Detailed Project Report
Mitigation of Mangan Landslide at North District Headquarters
Mangan, North Sikkim - India

COMPLIANCE REPORT

for Submission of Comments / Inputs on Revised DPR to NDMA

**MANGAN LANDSLIDES AREA
OLD MANGAN BAZAR & SNT COMPLEX- MITIGATION MEASURES
LAYOUT PLAN**

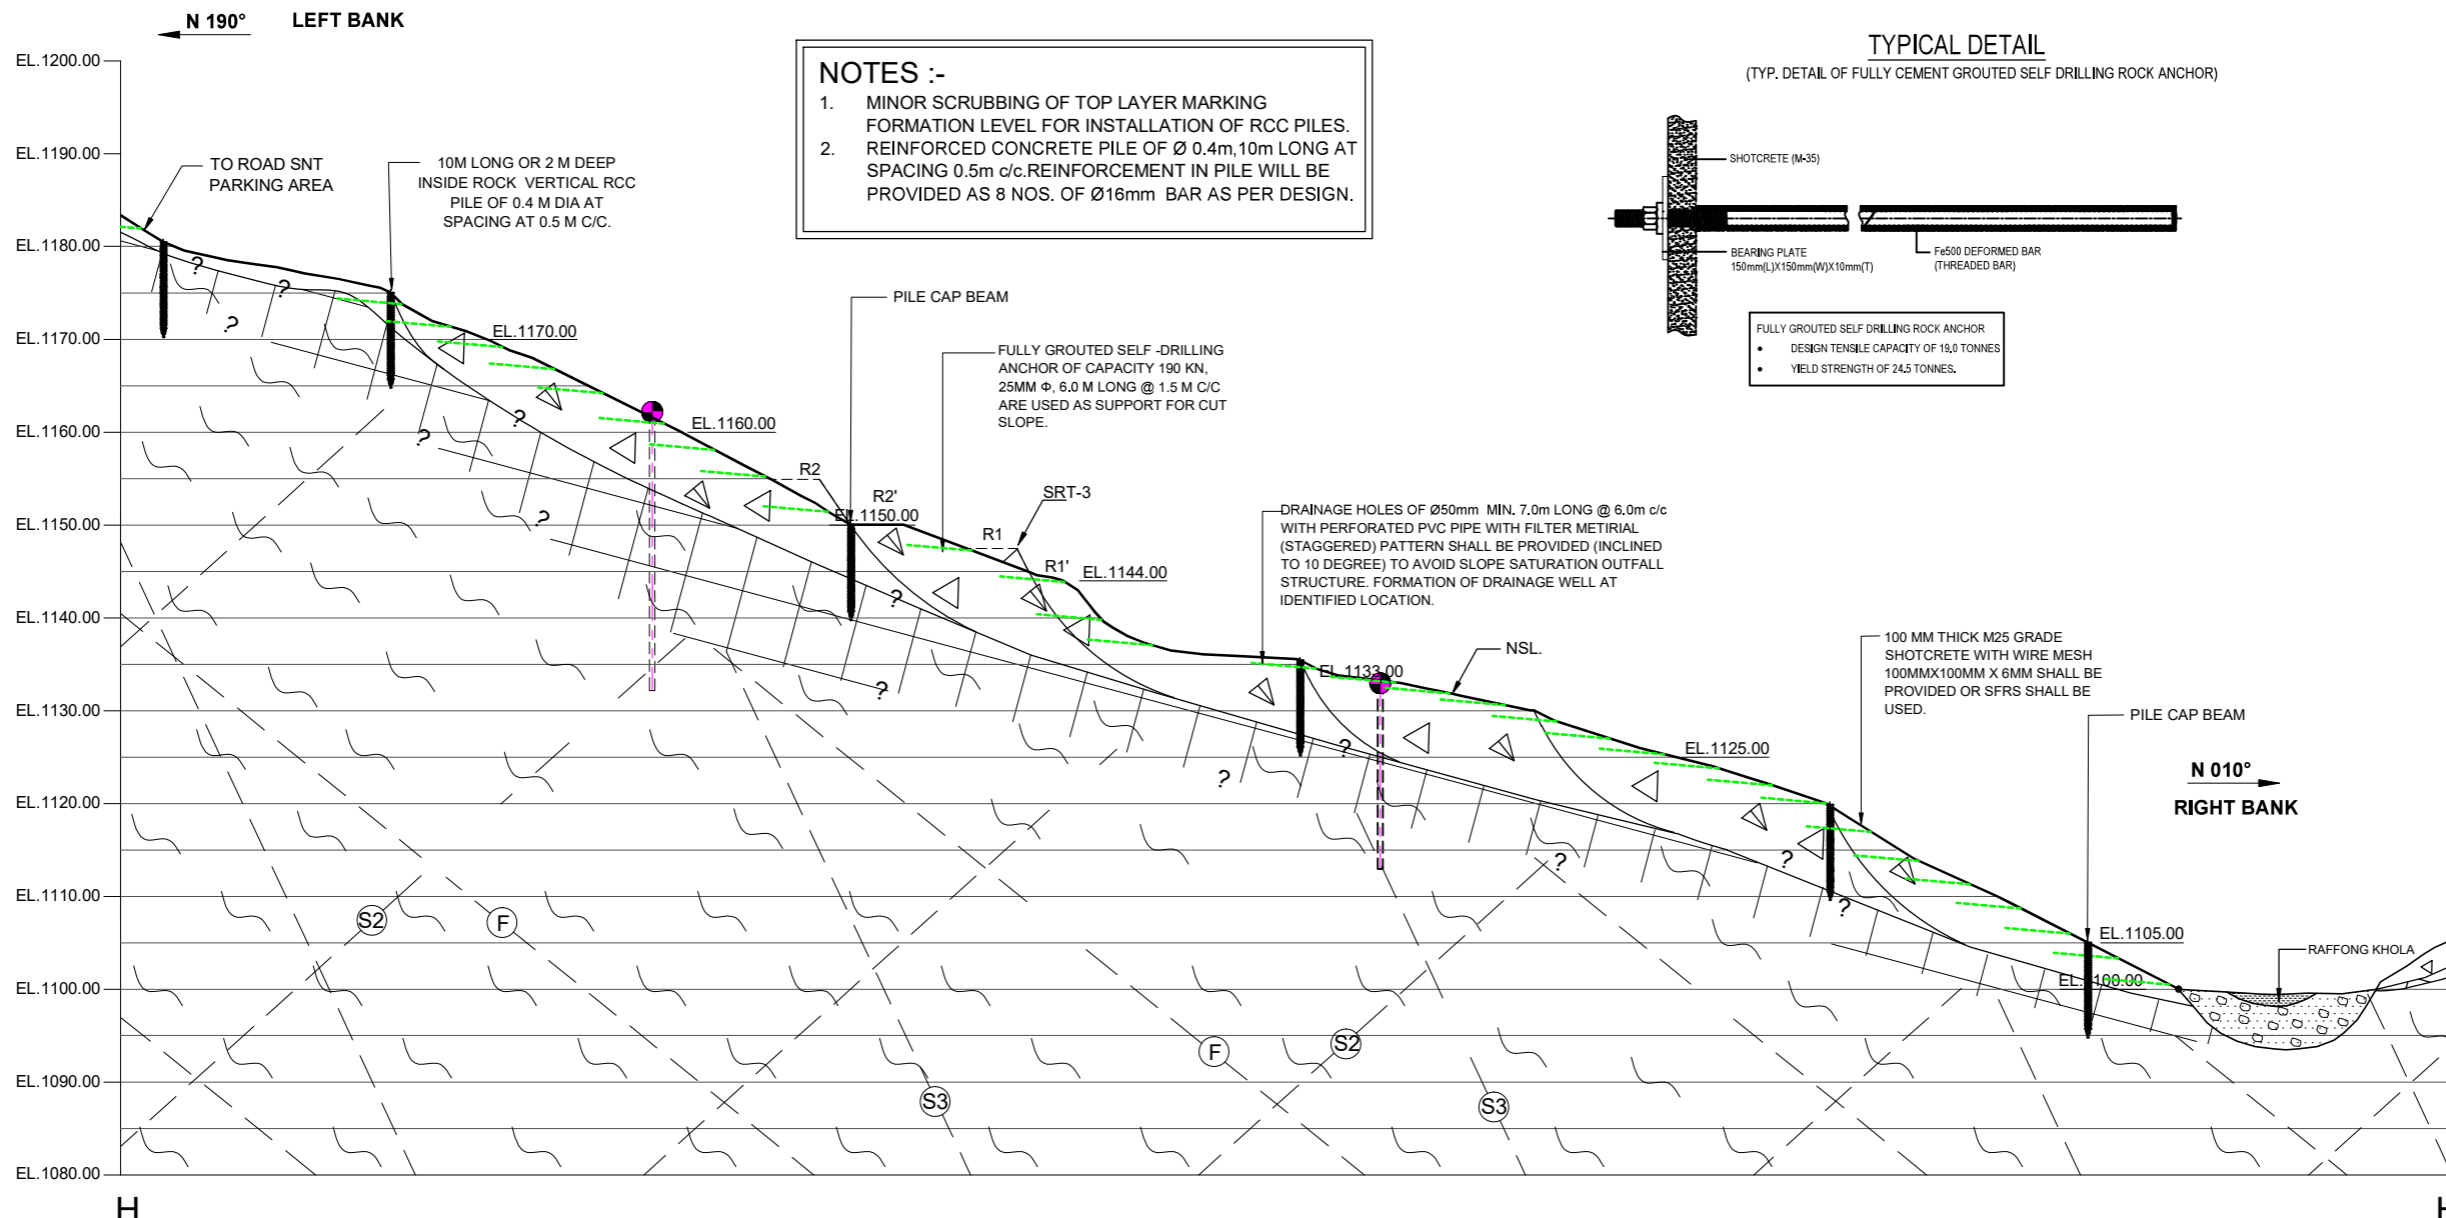
| Sl. No | Recommendation / Suggestion of member from GSI of TEC Experts in the Last Meeting & Clarification Sought | Clarification by the State | Reference Page no. of DPR |
|--------|---|----------------------------|--|
| 3. | Suitable designed surface and sub-surface drainage corrections shall be planned and implemented to drain out water from the affected area of the landslide and its upper reaches with appropriate weep holes. | Accepted. | Shown in the design drawings no. Mangan/Sikkim/SSDMA-113 & 114. |
